Shearon Harris Nuclear Power Plant, Unit 1
Docket No. 50-400
Renewed License No. NPF-63

Subject: License Amendment Request Regarding Administrative Change to Reflect
Development of a Technical Requirements Manual

Attachment 1: Proposed Technical Specification Changes (Mark-up)

FIGURE 3.4-4
 MAXIMUM ALLOWED PORV SETPOINT FOR THE LOW
 TEMPERATURE OVERPRESSURE PROTECTION SYSTEM

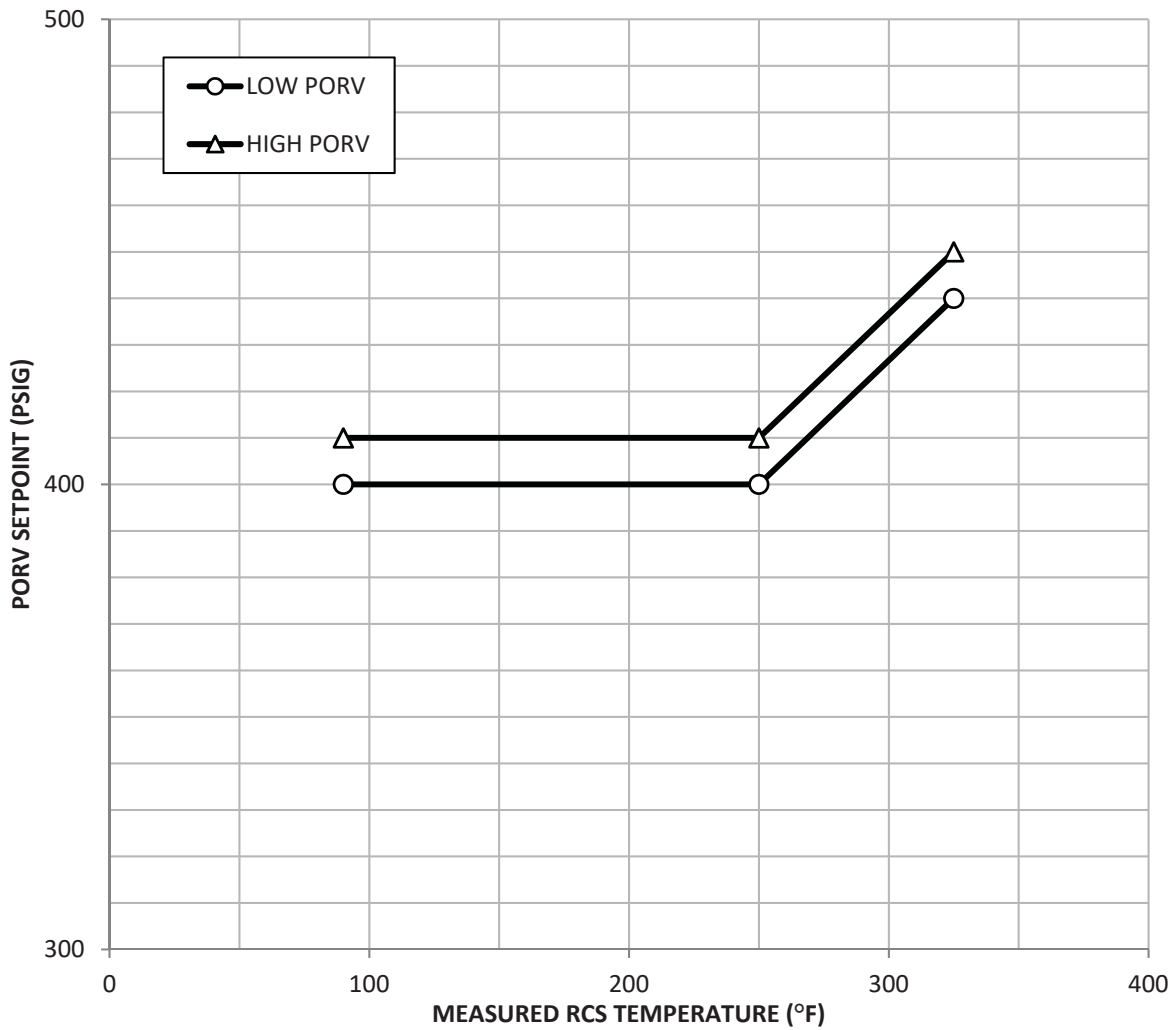
~~INSTRUMENT ERRORS ARE CONTROLLED BY THE TECHNICAL SPECIFICATION EQUIPMENT LIST PROGRAM, PLANT PROCEDURE PLP 106.~~

Technical Requirements Manual
